Reference: 24.014r03v03

Re: 40 Myoora Road, Terrey Hills
Council's Development Application No. DA2024/1362
TfNSW Reference: SYD24/01792/01
Response to Request for Information

Figure 1: Mona Vale Road / Aumuna Road / Kamber Road Intersection Performance Summary

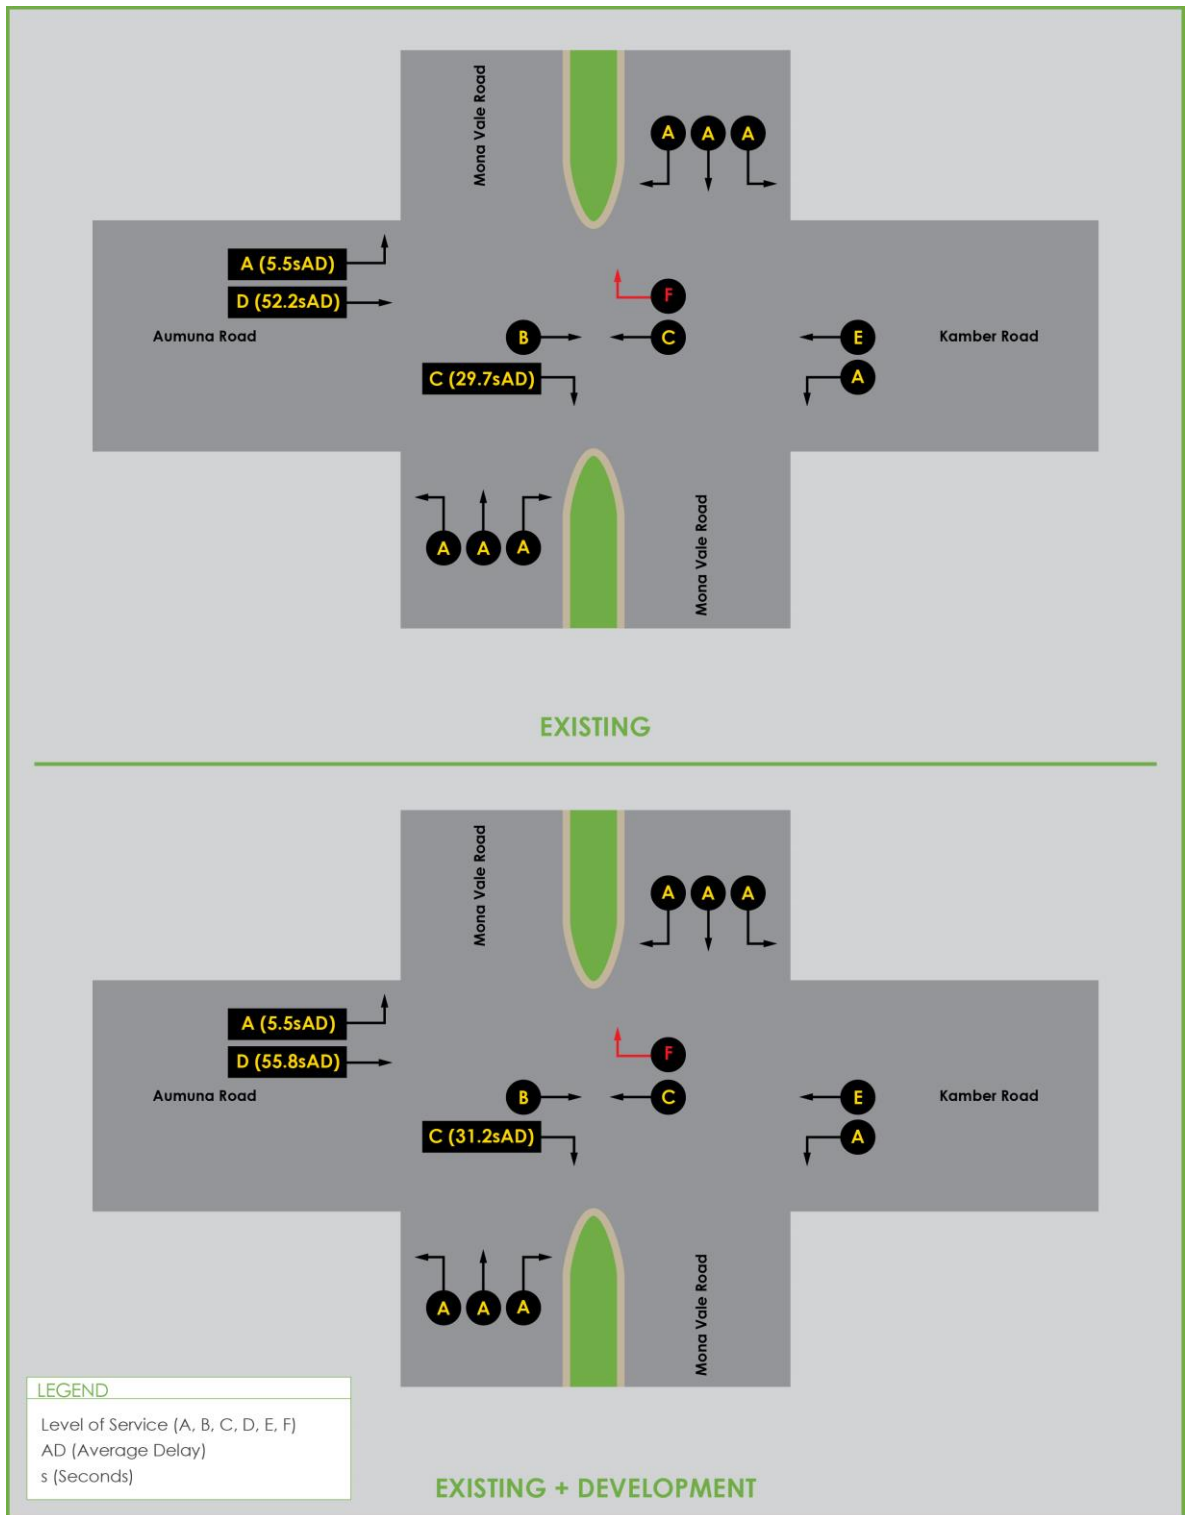
- 1) **Delays:** TfNSW notes that the DA will significantly increase the delay for vehicles at the Mona Vale Road/Aumuna Road intersection, with delays for right turns out onto Mona Vale Road increasing from 310 seconds to 403 seconds. The analysis provided shows that the Mona Vale Road/Aumuna Road intersection is currently performing very poorly, and that the additional traffic generated by the DA will create an unacceptable safety risk at this intersection. High delays at an intersection will likely encourage drivers to take risks. Given the road environment, such risks could result in high-speed, high-severity crashes. The currently submitted documentation does not include any transport or traffic amelioration measures at the above intersection to reduce the impact of the DA in terms of improving road safety and network efficiency outcomes that benefit the development's operations and the associated vehicular traffic that the DA will generate. The fact that an intersection is already performing poorly does not justify accepting further vehicle movements without implementing necessary improvements. The Applicant must investigate and propose suitable traffic mitigation measures to reduce delays and improve road safety at this intersection

The above modelling results show there will be no noticeable changes to the overall performance of the critical intersection of Mona Vale Road and Aumuna Road as a result of the proposed development and no upgrades are required to be made to this intersection, accordingly. Reference is made to the intersection performance summary figure presented in **Figure 1** below.

Whilst the intersection of Mona Vale Road and Aumuna Road currently fails and will continue to fail under the development scenario, this is due to vehicles turning right from Kamber Road onto Mona Vale Road, northbound and is not attributed to the additional traffic generated by the proposed development. Reference should be made to the intersection performance summary diagram presented in **Figure 1** above showing the Level of Service for each leg respectively for the existing and

existing plus development scenarios. Whilst there is a small increase to the average delay for vehicles turning right from Aumuna Road, eastbound onto Mona Vale Road, southbound, this is minor (+5.1 seconds in total), and the overall performance of the intersection will continue to operate at a Level of Service F with a slight improvement in average delay (-4.2 seconds) as shown in **Table A** above. This slight improvement is likely because more vehicles pass through the intersection without causing the worst performing movement (the right turn movement from Kamber Road onto Mona Vale Road) to perform any worse than it is already performing under the existing scenario.

Figure 2 Development Peak Hourly Vehicle Trips

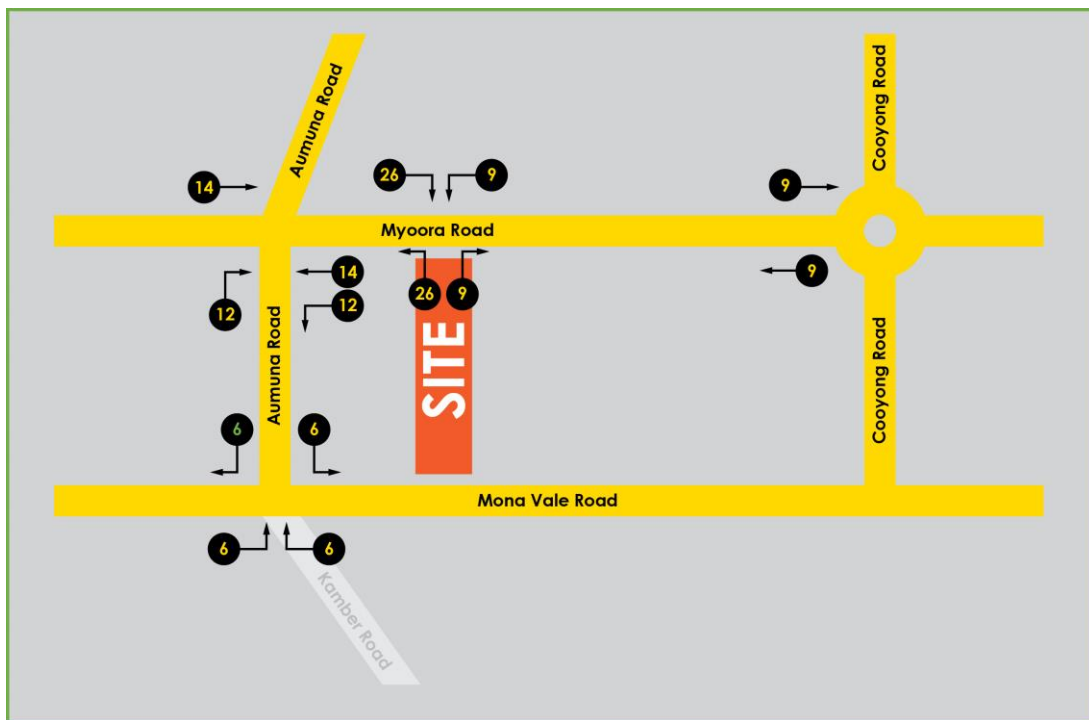
2) Trip Distribution TfNSW does not agree with the trip distributions as detailed in the Traffic Impact Assessment (TIA) prepared by Traffix (reference 24.01 4r01 v02, dated September 2024). A review of available Google data suggests that vehicles travelling from the development site to the east, south, and north are directed by Google Maps to exit via the Mona Vale Road and Aumuna Road intersection. Although some vehicle movements generated by the development may “take advantage of alternative more convenient vehicle routes using nearby signalised intersections to turn right onto Mona Vale Road” most vehicle movements will utilise the Mona Vale Road and Aumuna Road intersection.

Furthermore, the critical movement involving vehicles departing the subject site and turning right from Aumuna Road (eastbound) onto Mona Vale Road, southbound will result in an additional six (6) vehicles per hour undertaking this manoeuvre during peak times which is considered minor (equivalent to one additional vehicle every 10 minutes) and will have no noticeable impact on the performance of this intersection. A summary of additional vehicle movements caused by the proposed development, including the additional six (6) additional vehicles per hour turning right from Aumuna Road, eastbound onto Mona Vale Road, southbound (in green) is shown in **Figure 2** below for clarity.

Reference should be made to the intersection survey results presented in **Attachment 2** which demonstrates that during the critical Saturday peak at the intersection of Myoora Road/Aumuna Road between 10:15am-11:15am, only 17% of vehicles approached the intersection via the northeastern leg of Myoora Road and turned left onto Aumuna Road, southeast towards the intersection of Aumuna Road/Monavale Road.

The adopted trip distributions as assessed in the Traffic Impact Assessment assigned 75% of outbound vehicles to exit the site and turn left onto Myoora Road and 50 % of those vehicles were assigned to turn left onto Aumuna Road, southwest which is considered a conservative assessment. For context, if 100% of outbound vehicles exited the subject site and turned left onto Myoora Road and 17% of those vehicles turned left onto Aumuna Road at the intersection of Aumuna Road / Myoora Road as per the intersection surveys, then only 17% of vehicles exiting the subject site would turn left onto Aumuna Road, less than the 25% of vehicle trips as assessed in the TIA.

For clarity, a vehicle trip diagram of all additional vehicle trips generated by the subject development during peak operating hours is presented in **Figure 2** above.
